## **Proposal for Supplement 42 to the 03 series of amendments of Regulation No. 37**

### **Submitted by the expert from the International Automotive Lighting and Light Signalling Expert Group (GTB)\***

The text reproduced below was prepared by the expert from the International Automotive Lighting and Light Signalling Expert Group (GTB) to introduce light source categories WT(Y)21W and WT(Y)21/7W. The modifications to the existing text of the Regulation are marked in bold for new or strikethrough for deleted characters.

## Sheet WT21W/1

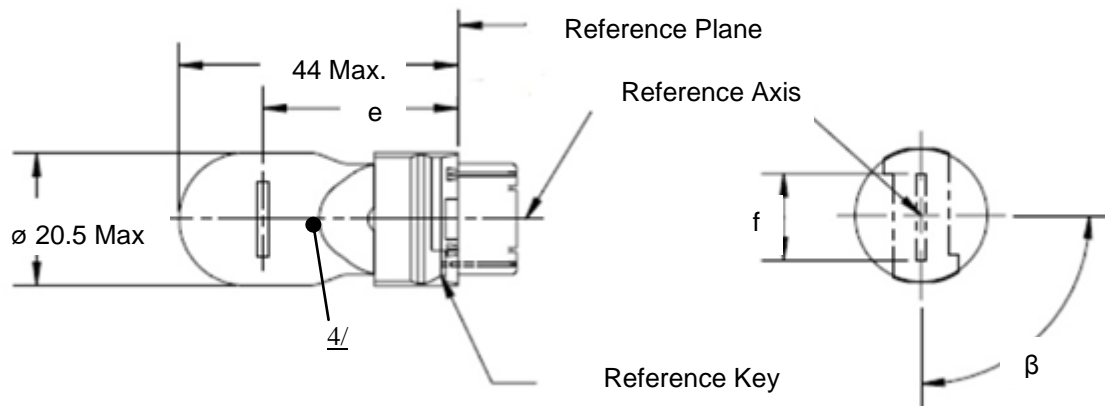
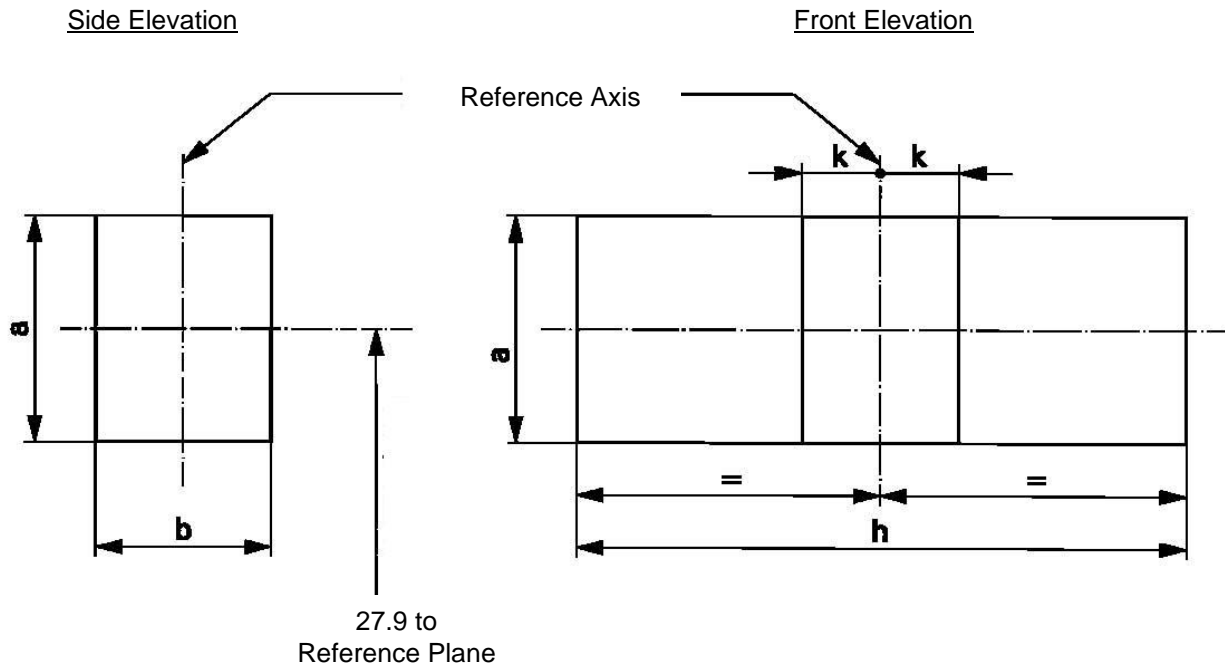
*Insert new sheets WT21W/1 to 2 and WT21/7W/1 to 3 between sheet WR21/5W/1 and sheet WY2.3W/1, to read: (see next pages):*

Dimensions in mm		Filament lamps of normal production			Standard filament lamp
		min.	nom.	max.	5/
e	12V		27.9 <sup>3/</sup>		27.9 ± 0.3
	24V	26.9	27.9	28.9	
f				7.5	7.5 + 0/ - 2
Lateral deviation <sup>2/</sup>	12V			<sup>3/</sup>	0.0 ± 0.4
	24V			1.5	
β		75° <sup>3/</sup>	90°	105° <sup>3/</sup>	90° ± 5°
Cap: WT21W: [WUX2.5x16d] in accordance with IEC Publication (sheet 7004-[....]-1)					
WTY21W:[WUY2.5x16d] 60061 (sheet 7004-[....]-1)					
Electrical and photometric characteristics					
Rated values	Volts	12	24	12	
	Watts	21			21
Test voltage	Volts	13.5	28.0	13.5	
Objective values	Watts	26.5 max.	29.7 max.	26.5 max.	
	Luminous flux	WT21W	460 ± 15 %		
		WTY21W	280 ± 20 %		
Reference luminous flux at approximately 13.5 V:					White: 460 lm Amber: 280 lm
